DrawDiff Comparison Report

Part number: DA1840189 | Job: 73a68852-0922-41cf-abf3-9311117452ac | Generated: 2026-04-28T06:02:43+00:00

VIEW_8 [MATCHED]

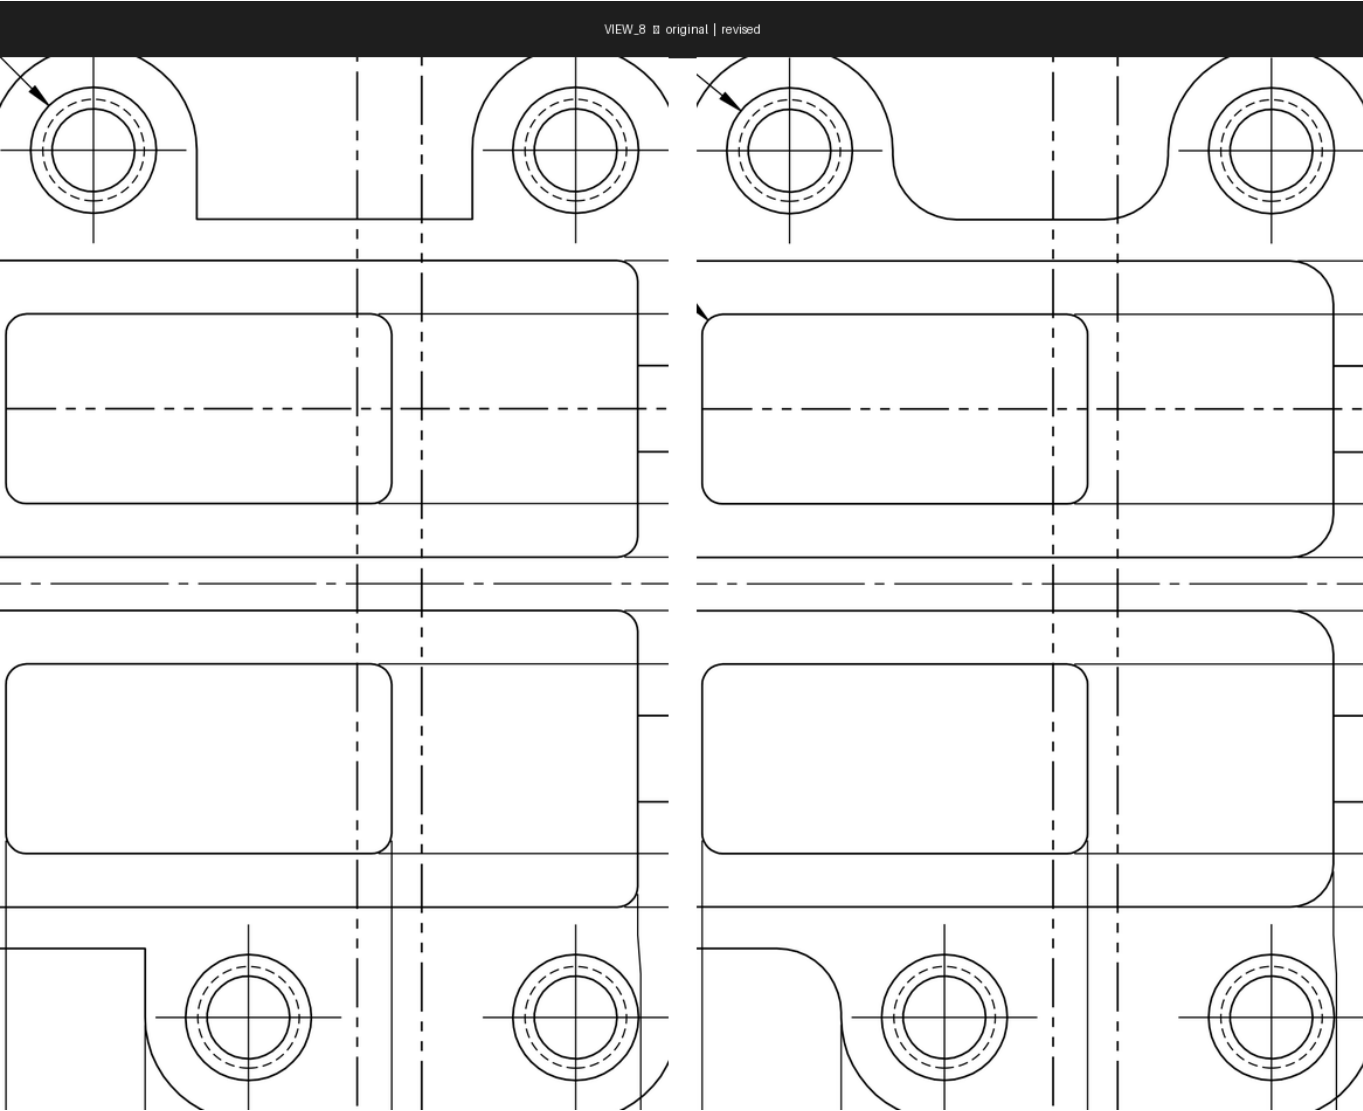
Severity	Field	Original	Revised	Conf.	Rationale
CRITICAL	geometry	Sharp/chamfered corners on top center cutout (notch between mounting bosses)	Large radius fillets on top center cutout corners	0.92	The top center notch transitions from sharp/square corners to large radiused corners, significantly changing the geometry and stress concentration at those features.
